Part 5 Application **ACCESS REPORT**

Reference Number: 24196

Integrated Design Group (for Homes
NSW)

1-3 Rodd Street, Eden NSW

[Image description: Plan of the ground floor above shows the provision of Accessible parking spaces]

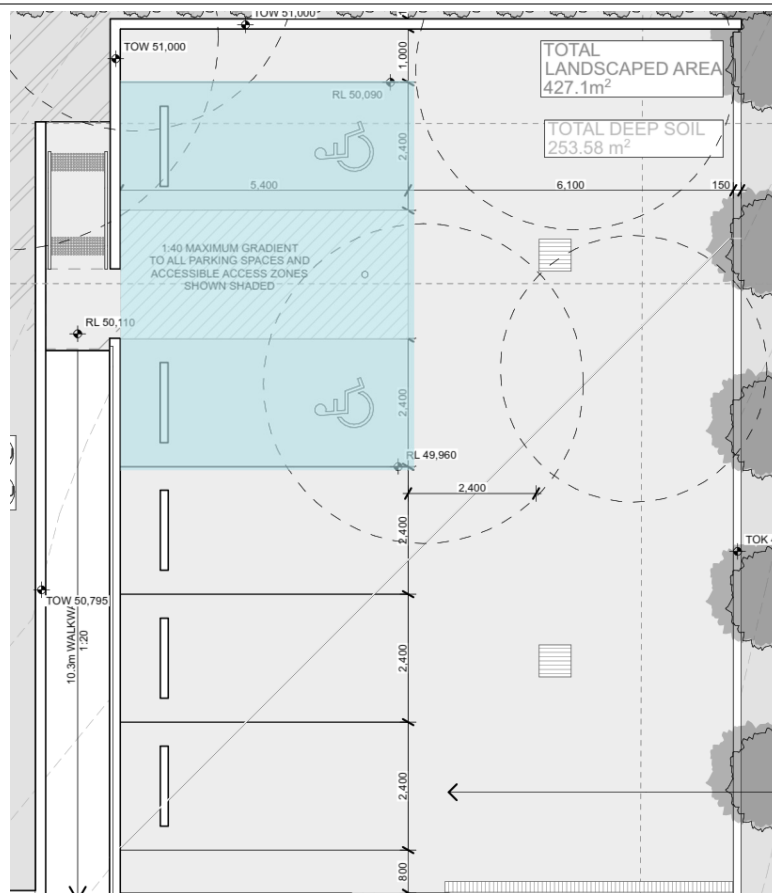
Parking is to be provided to the development in line with the SEPP guidelines. 2 x accessible parking spaces in accordance with AS2890.6 have been provided.

Note: refer to comments from HNSW planners for parking requirements
